Change Notice

FT Series

IC Chip for Analog Touch Screen Controller Board

Replacement IC Chip Used in Controller Boards

Discontinued Product	Alternate Product
FTCSU564	FTCSU548

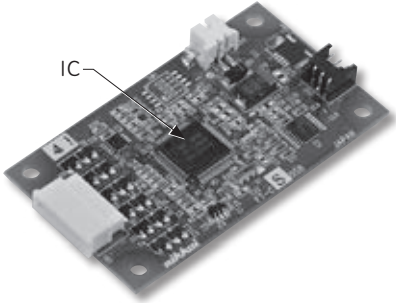
1. The FT Series IC chip for the analog touch screen controller board will be discontinued and replaced with an alternate IC chip. This change applies to standard and custom products.

General Specifications Comparison		
	FTCSU564 (Discontinued)	FTCSU548 (Alternate)
Package	QFP 64 Pins	LFQFP 48 Pins
Interface	Serial Interface (Asynchronous) or USB (Full Speed 2.0)	Serial Interface (Asynchronous) or USB (Full Speed 2.0)
Supply Voltage	3.3V/5.0V Typ; USB available for 5V only	3.3V/5.0V Typ; USB available for 5V only
Power Consumption	500mW (Temperature at 25°C)	—————
* Rated Output Current	—————	1. -170mA 2. +170mA
Operation Frequency	6MHz	16MHz
A/D Converter Resolution	10bit	10bit
Operating Temperature	-20°C ~ +85°C (-4°F ~ +185°F)	-20°C ~ +85°C (-4°F ~ +185°F)
Storage Temperature	-40°C ~ +125°C (-40°F ~ +257°F)	-40°C ~ +125°C (-40°F ~ +257°F)

The alternate IC chip for FT Series will be available March 6, 2017.
